**E4416A-10**

# S E R V I C E N O T E

## Agilent E4416A EPM-P Peak & Average Power Meter

### Front Panel Dimension Might Not Be Suitable For Rack Mounting Solutions

Figure 1

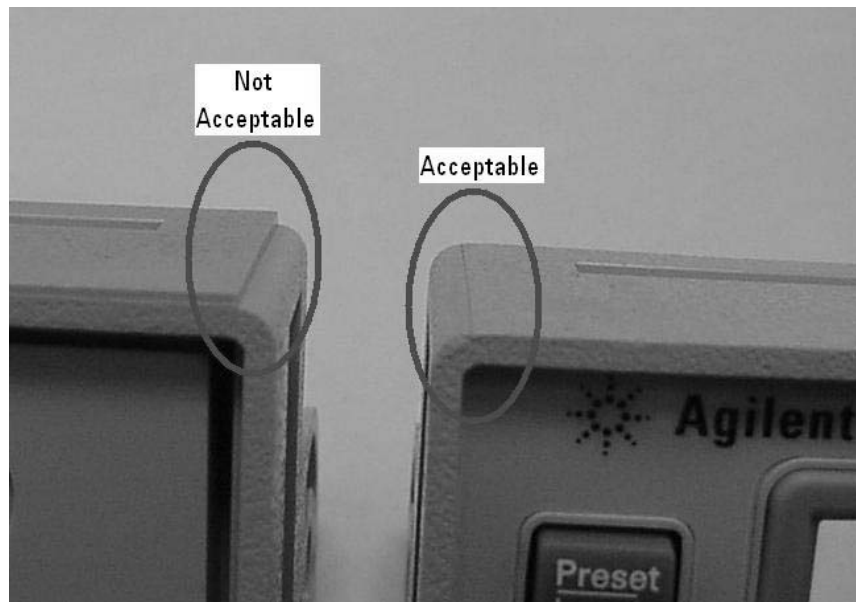
A tooling issue has resulted in some E4416A power meters being shipped with excess material on the top edge of the Front Panel Assembly. The height of this excess material varies, but it has been noted that when it exceeds 0.5mm the meter may no longer be suitable for rack mounting solutions.

Figure 1 shows the physical difference between an acceptable and an unacceptable Front Panel Assembly.

If the height of the excess material is 0.5mm (or less), then no further action is necessary.

If the height of the material exceeds 0.5mm, then the Front Panel Sub-assembly must be replaced (refer to Service Note E4416A-08 for instructions on how to remove & replace the Front Panel Sub-Assembly).
